TOWNSHIP OF NORTH DUMFRIES BUILDING DEPARTMENT

These Plans have been examined for Compliance with the Ontario Building Code requirements. A Building Permit has been Issued, subject to any changes noted, under the condition that the building will be constructed in accordance with the code.

Tice River Homes

Legacy

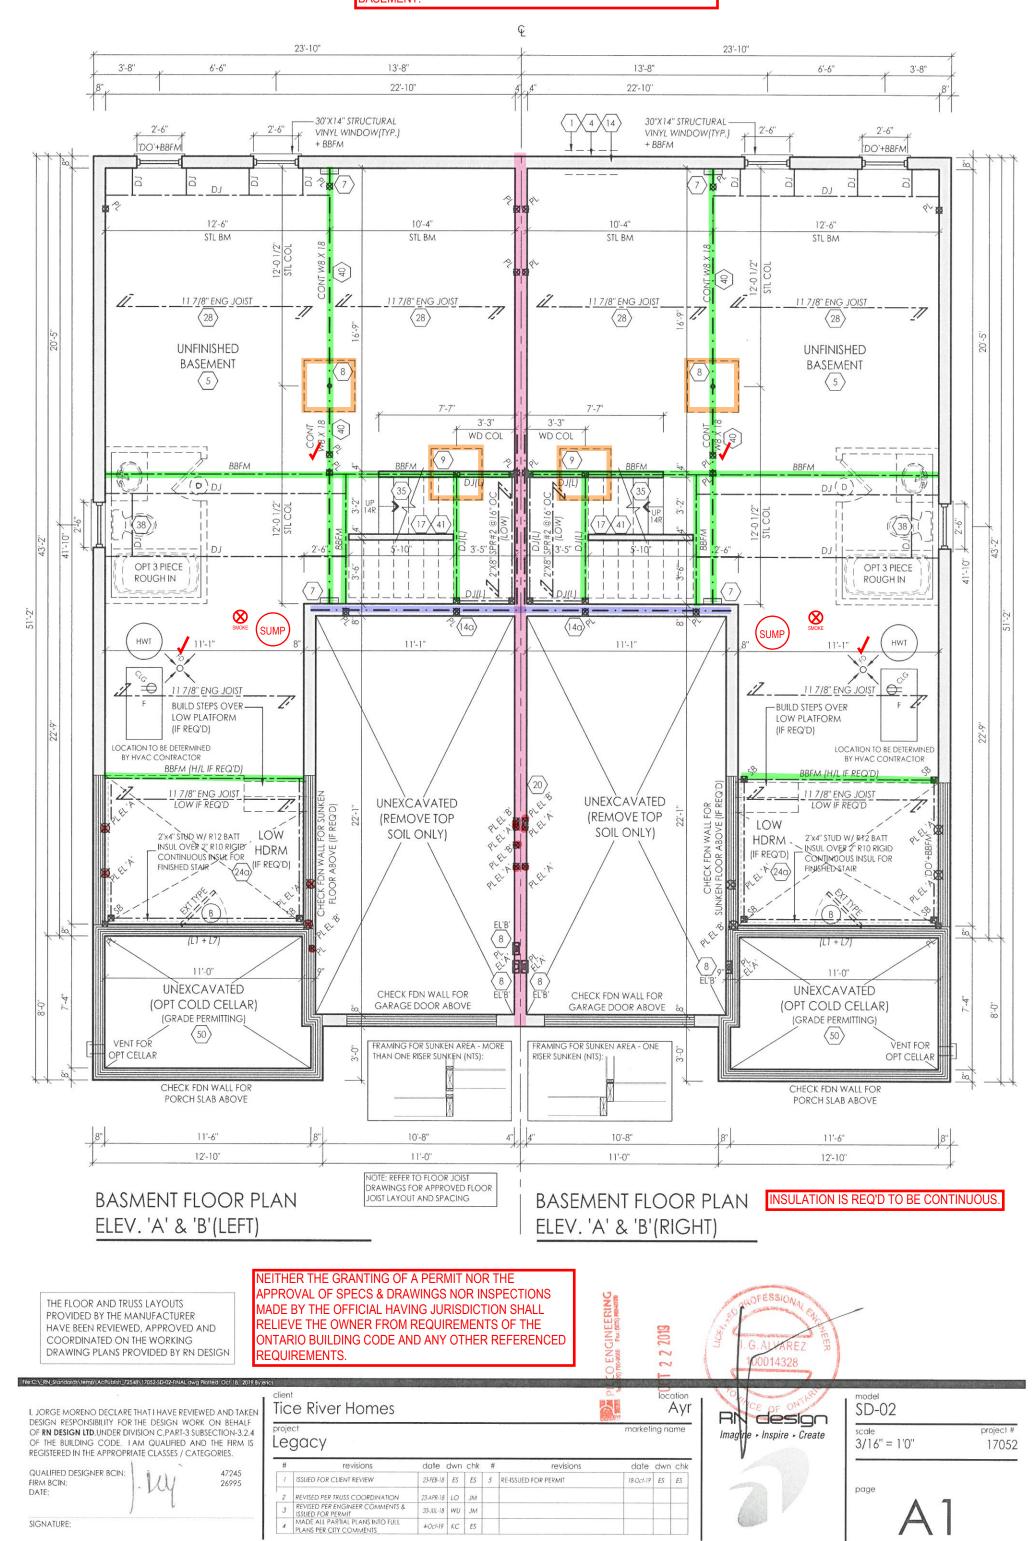
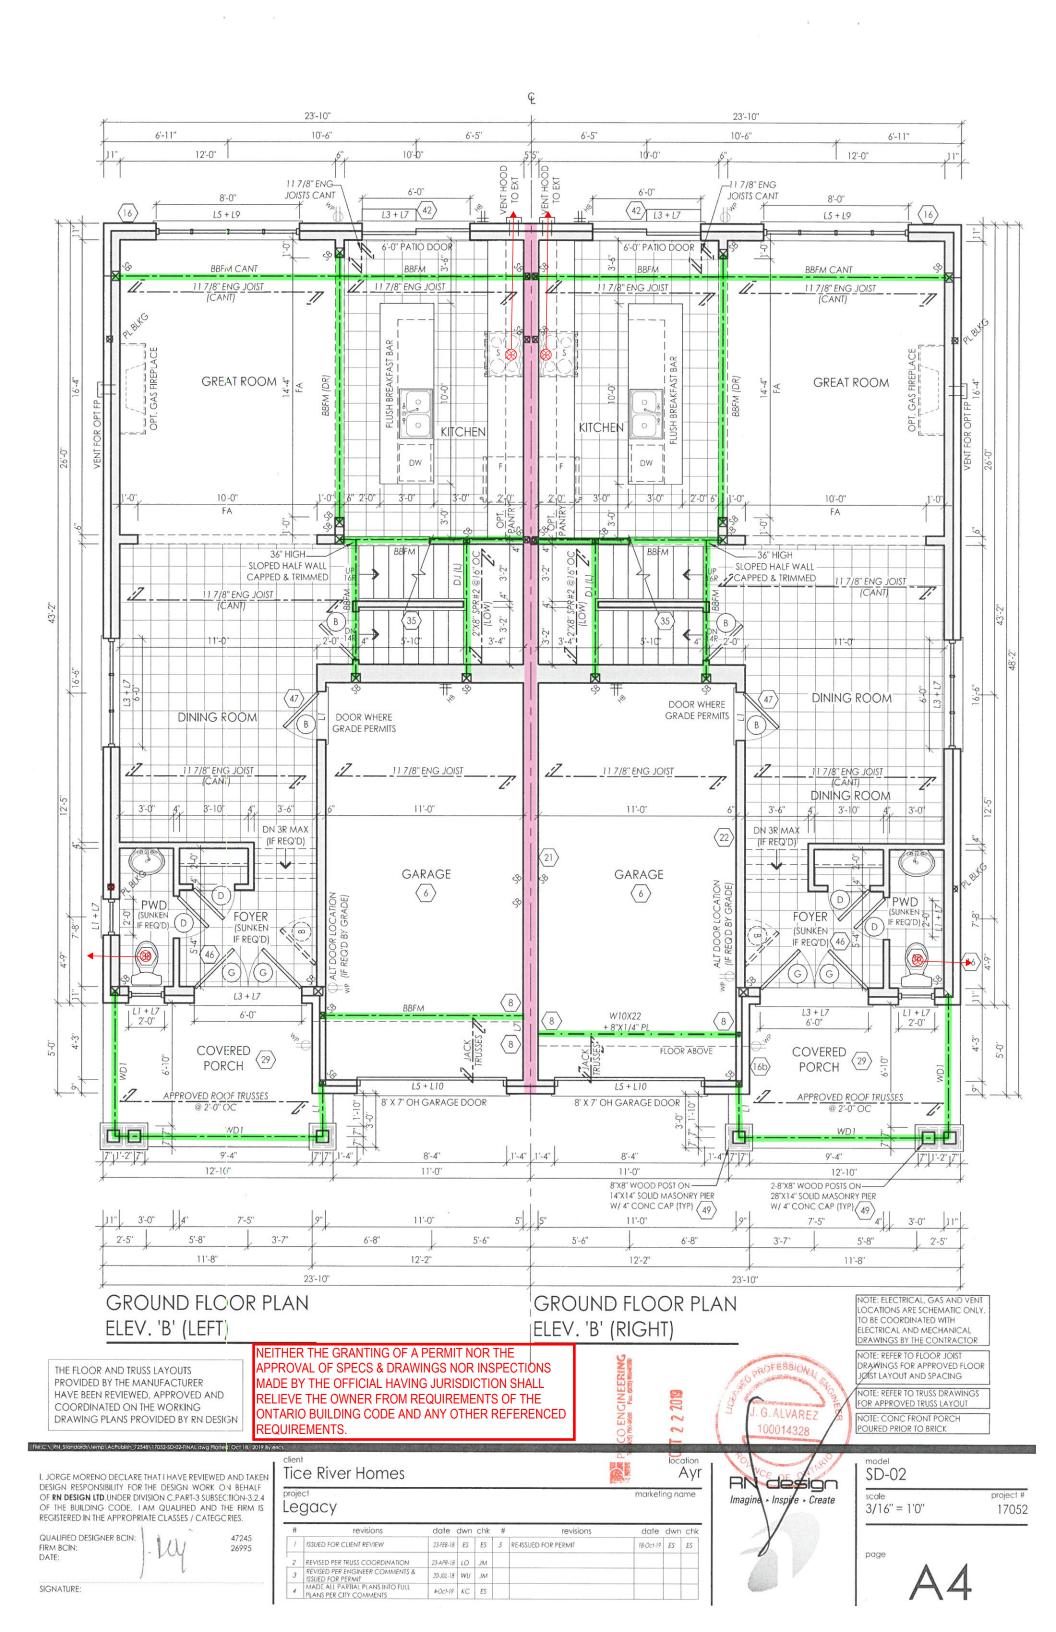
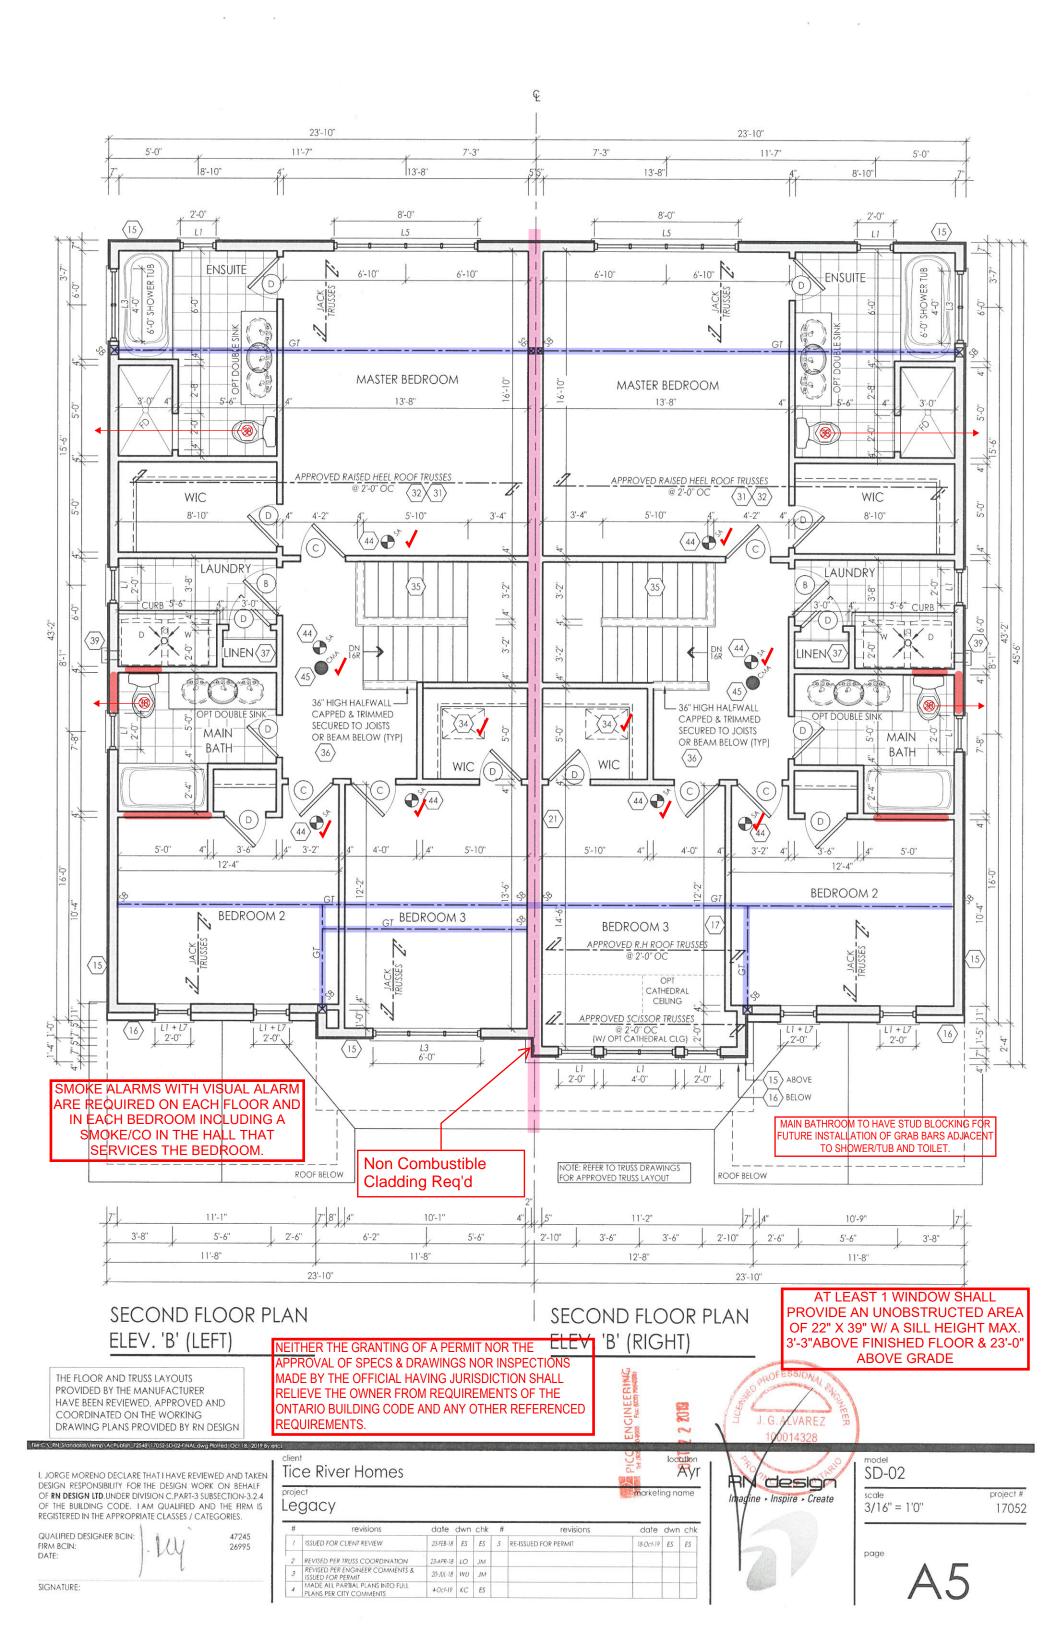
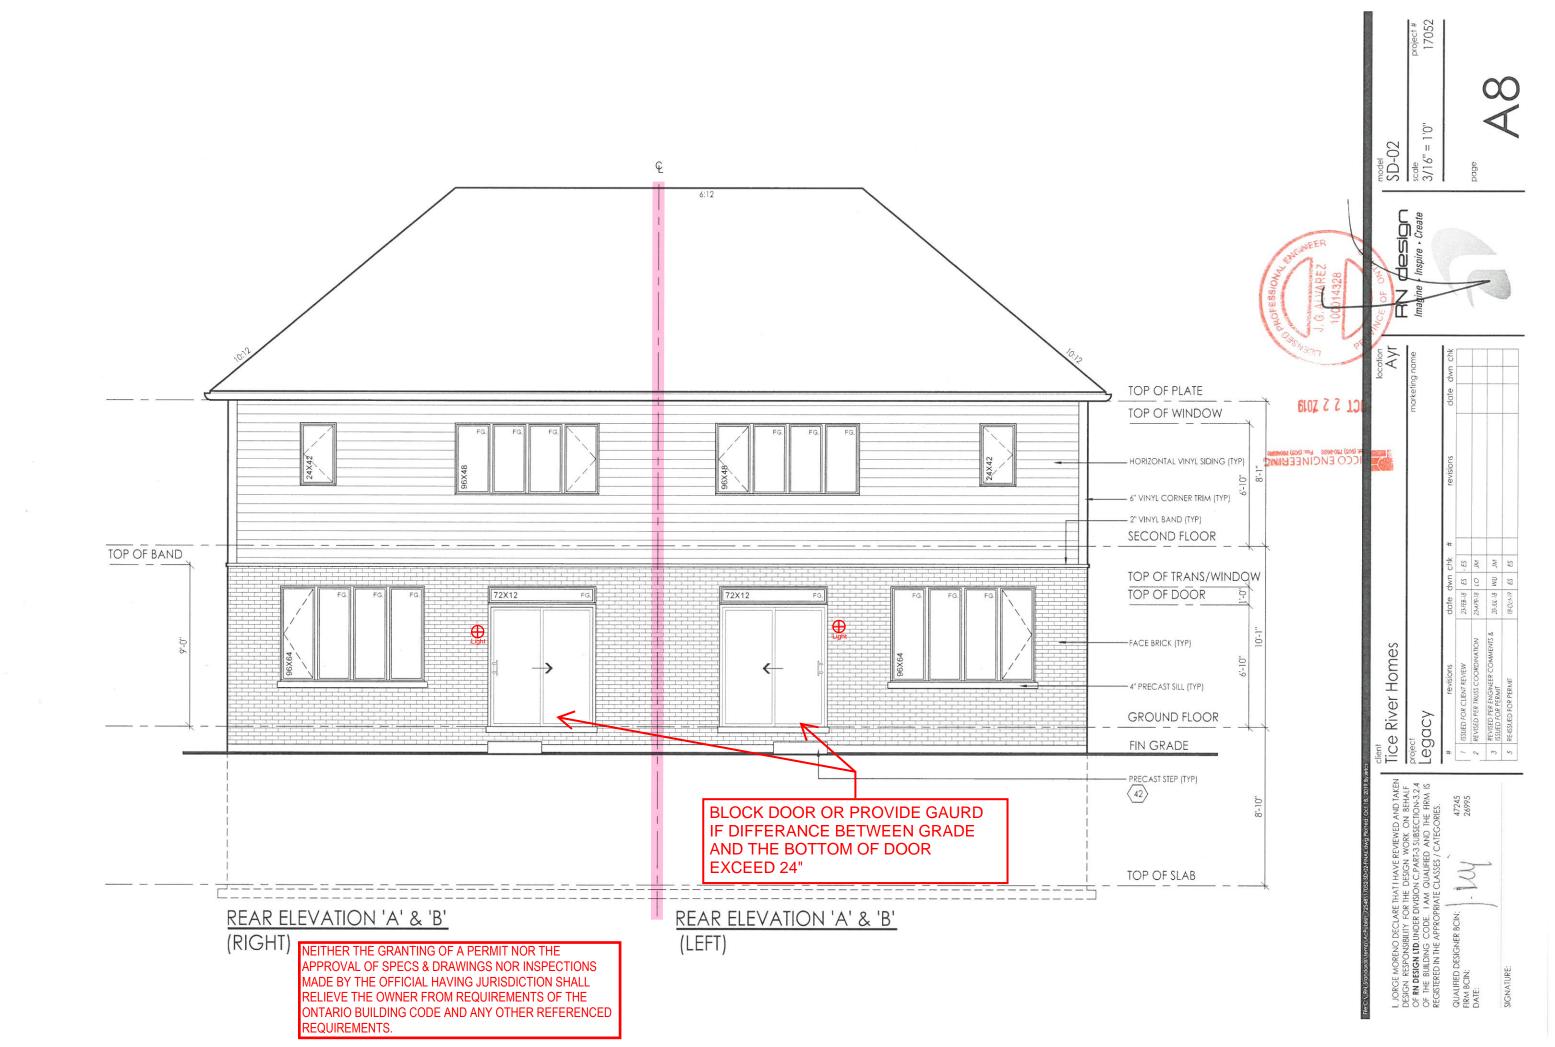
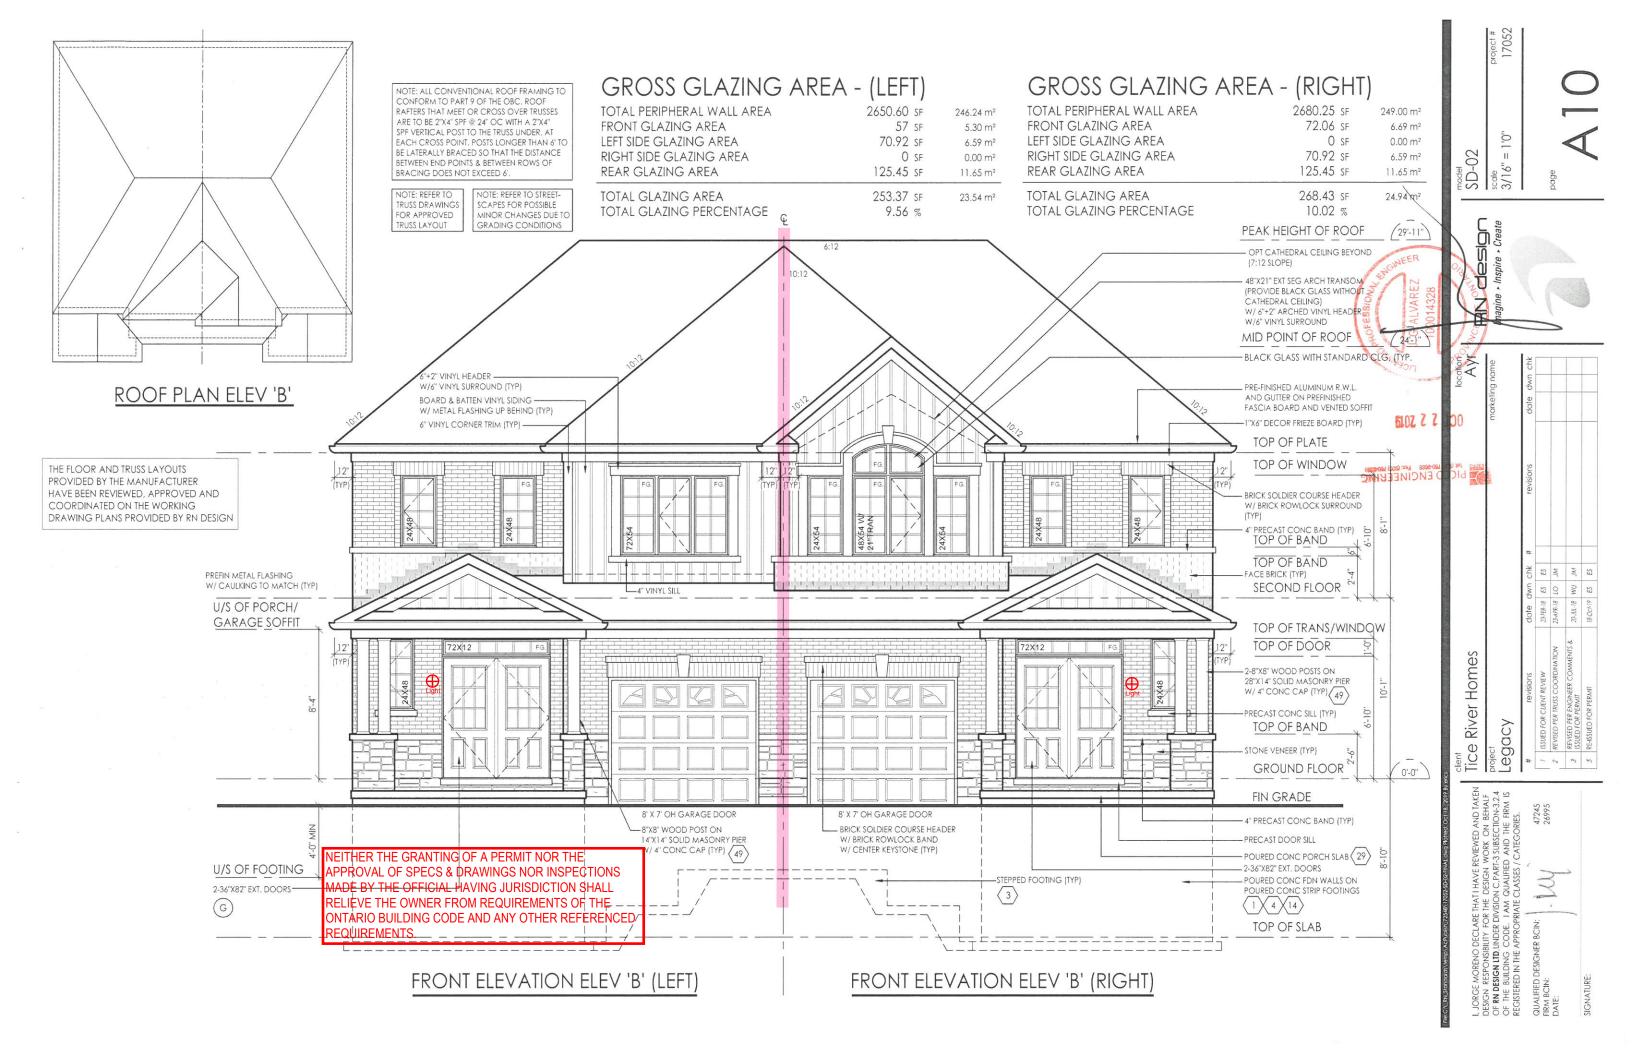
APPROVED DRAWINGS HAVE BEEN RED LINED INDICATING A CHANGE TO MEET THE OBC. PLEASE REVIEW ALL PAGES TO ENSURE YOU ARE PROPERLY INFORMED OF CHANGES.

TIGHTLY FIT ELECTRICAL BOXES WHERE BOXES ARE LOCATED ON BOTH SIDES OF WALL PROVIDING A F.R.R., OFFSET BOXES AT LEAST ONE STD SPACE TO MAINTAIN INTEGRITY OF FIRE SEPARATION.

CALL FOR INSPECTION OF EXCAVATION CRIBBING BEFORE POURING ANY CONCRETE

ANY MODIFICATIONS TO GRADING SHALL NOT ADVERSELY AFFECT **NEIGHBORING PROPERTIES**

INAL GRADING CERTIFICATE REQUIRED BEFORE FINAL **INSPECTION SIGN-OFF**
